# PLANNING CLEARANCE

Building Address 460 N 17th Street  
 Parcel No. 2945-132-17-002  
 Subdivision Slocombs Add.  
 Filing \_\_\_\_\_ Block 3 Lot 1-3

# IMPROVEMENT LOCATION CERTIFICATE

RE: 460 N 17<sup>th</sup> Street  
2945-132-17-002

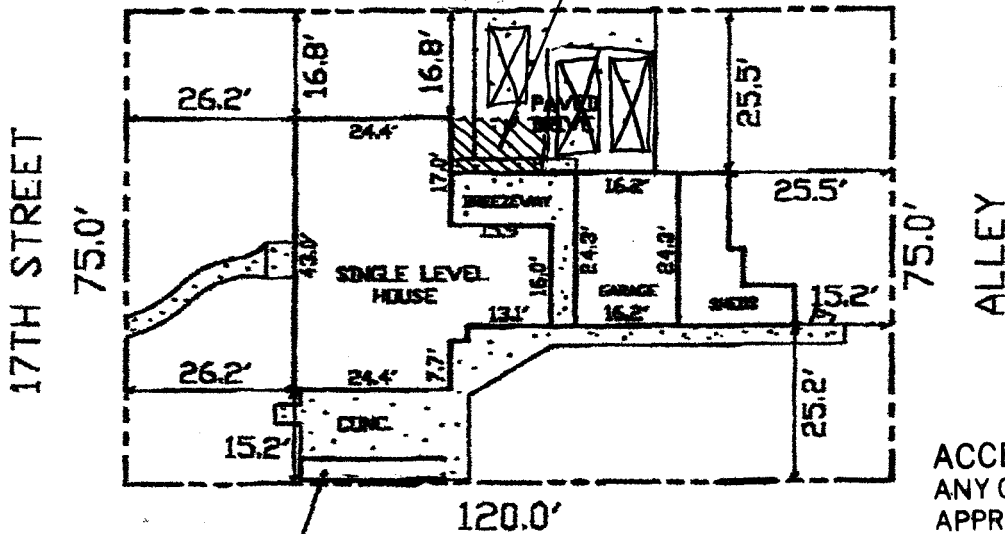
NEW ADDITION AREA  
13'x10'

ACCEPTED *Ronnie* RPA 12/13/04  
ANY CHANGE OF SETBACKS MUST BE APPROVED BY THE CITY PLANNING DEPT. IT IS THE APPLICANT'S RESPONSIBILITY TO PROPERLY LOCATE AND IDENTIFY EASEMENTS AND PROPERTY LINES.

Based on this section of the Code, the mean of the setback of the adjacent house and the required setback is calculated to be 15'. Therefore, the requested setback of 16.8' for the proposed addition at 460 North 17<sup>th</sup> Street is acceptable. Any further changes or addition must be submitted for review by the City Community Development Department.

**From:** Nina McNally  
**To:** Bobbie Paulson  
**Date:** 12/8/2004 8:46:33 AM  
**Subject:** 460 N. 17th St.

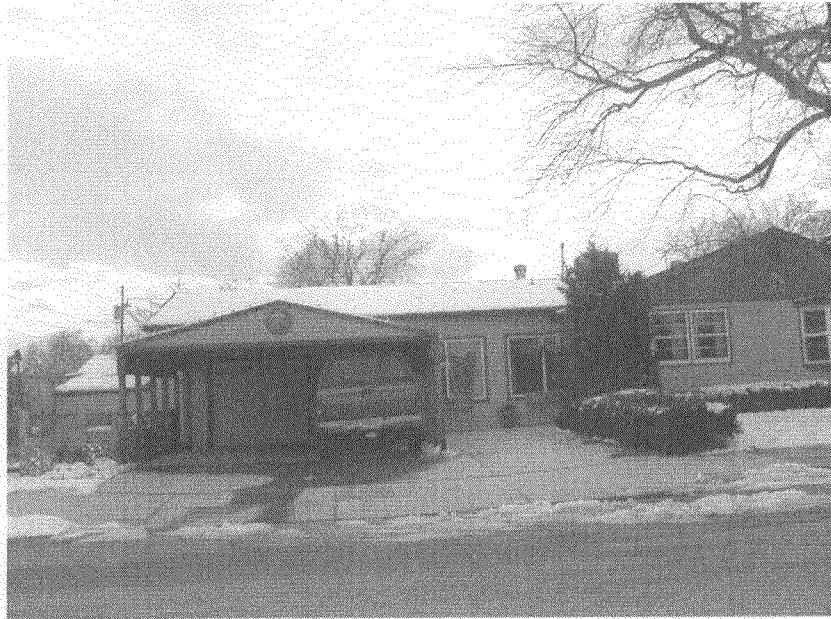
Here are the pictures. The sidewalk on Ouray is 7 ft wide total measuring from curb to inside edge of walk. The owner came out while I was there and was explaining how much more work would be involved if he has to meet the setback requirement because of moving hot water heat etc. etc. Aesthetically I think it would look better if the addition was flush with the existing structure, just my opinion. Let me know if you need anything else.

- #2 Side yard facing Ouray where addition is proposed.
- #3 Walk on Ouray facing west.
- #5 Side yard view from N side of Ouray.
